# COUNCIL ASSESSMENT REPORT

<b>Panel Reference</b>	PPSHCC-163
<b>DA Number</b>	DA2022/1362
<b>LGA</b>	MidCoast Council
<b>Proposed Development</b>	<p>Demolition of structures and construction of new health services facility (cancer treatment clinic):</p> <ul style="list-style-type: none"> <li>• Demolition of two existing dwellings and associated structures;</li> <li>• Construction of two-storey health services facility comprising: <ul style="list-style-type: none"> <li>○ LINAC/radiation treatment room;</li> <li>○ CT room;</li> <li>○ Two consultation rooms;</li> <li>○ Two oncology chairs;</li> <li>○ Staff rooms;</li> <li>○ Reception; and</li> <li>○ Waiting room.</li> </ul> </li> <li>• Two car parking areas accommodating a total of ten (10) car parks and one (1) pick-up/drop off space;</li> <li>• Landscaping of the site; and</li> <li>• Provision of necessary services and infrastructure.</li> </ul>
<b>Street Address</b>	<p>Lot 56 DP 626521 &amp; Lot 6 DP 666993</p> <p>88 Cornwall Street TAREE NSW 2430</p>

<b>Report prepared by</b>	Ben Lim-Cooper, Senior Development Planner MidCoast Council
<b>Report date</b>	4 October 2023

Figure 3 – Proposed Ground Floor Plan (Source: Team 2 Architects)

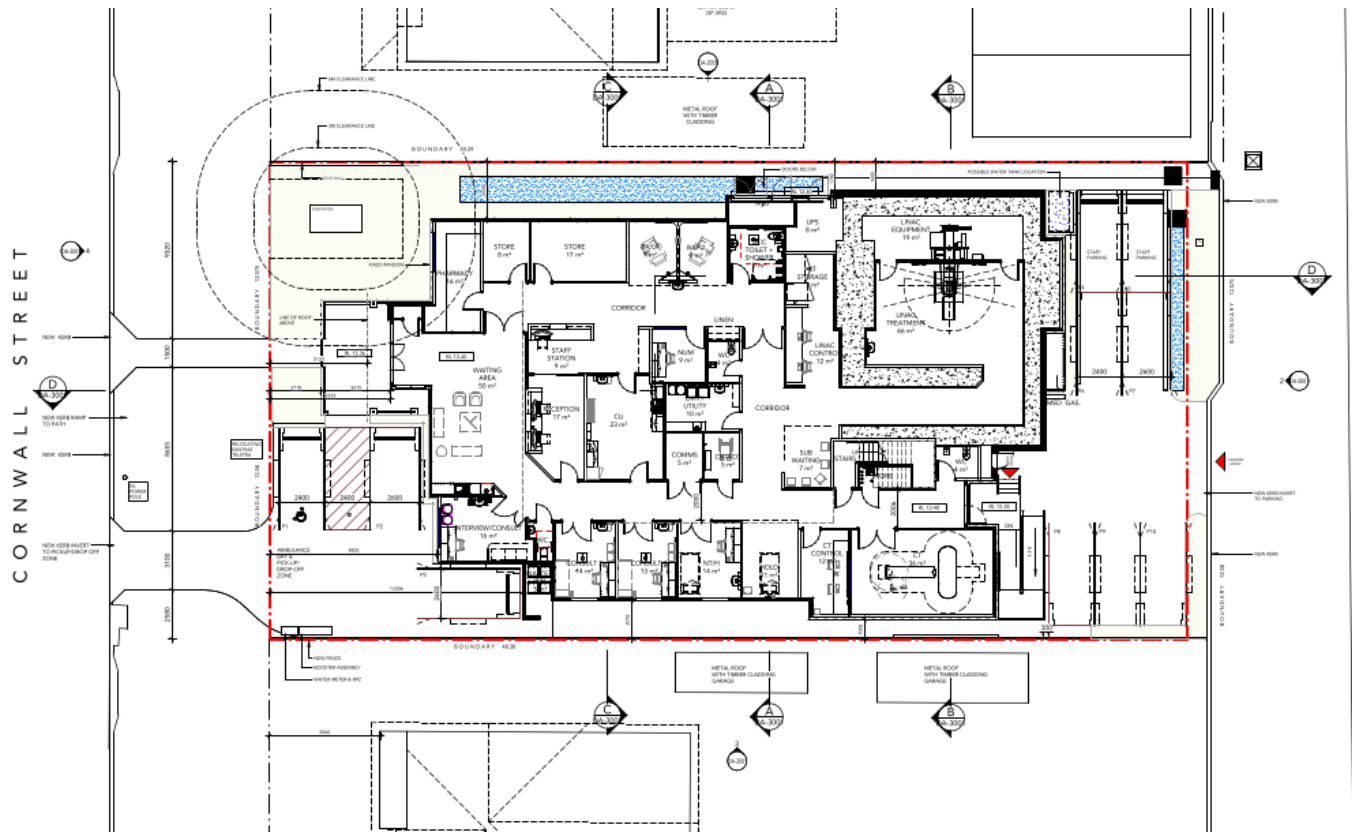
The proposed development includes seven car parks within the southern section (rear) of the site, four of which are in a stacked arrangement. Three car parks and a pick-up/drop-off area are located within the northern section (front) of the site.

The car park within the northern section of the site provides three car parking spaces. Amongst this car park, a pick-up/drop-off area is provided. This space conflicts with the car parking spaces in this area by restricting manoeuvrability and obstructs access to the car parking spaces from the street.

Furthermore, use of the pick-up/drop-off area requires vehicles to reverse onto Cornwall Street to exit the site which is an arrangement not supported in this context.

Figure 5 – Proposed Elevations (Source: Team 2 Architects)

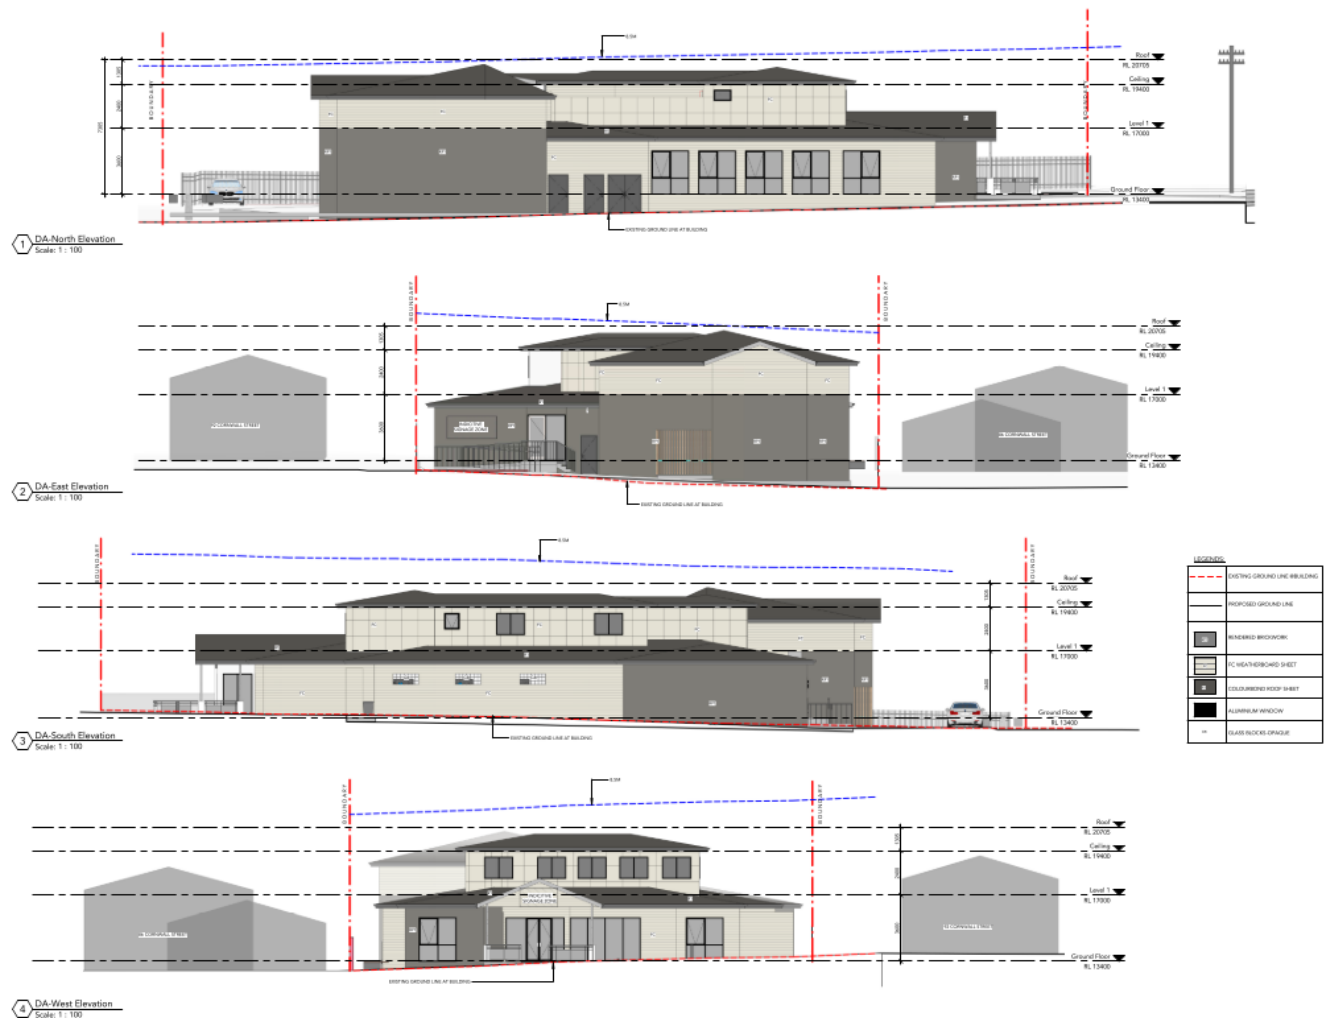
Notwithstanding the above, concerns still remain with the presentation of part of the north-eastern elevation associated with the LINAC/Radiation Treatment Room. In Council's letter dated 2 March 2023, the following was raised:

*Relevant to Part H3.1 of the DCP and compatibility with surrounding residential development, the side setback of the northern elevation of the LNAC Treatment room maintains a side setback of 900mm. As the wall height of this elevation is considered 'two-storey', a minimum side setback of 1600mm is required. This portion of the proposed building is considered to be visually dominant when viewed from adjacent private open space and Cornwall Lane. The slope of the land, which slopes away from within the site toward the land adjoining the northern boundary, further accentuates the visual dominance of this structure. The lack of articulation or visual interest of this portion of the building further contributes to visual impacts.*

Whilst it is acknowledged the applicant has since increased the side setback of this part of the building, Council's initial concerns regarding the visual impacts of this part of the building still remain. Whilst a mixture of materials and finishes have been incorporated, this part of the elevation provides no physical articulation such as building modulation or windows which would be expected for a residential dwelling development. This lack of articulation, compounded by the overall height of the wall, results in a visual presentation that is inconsistent with the surrounding residential setting in which it is located.
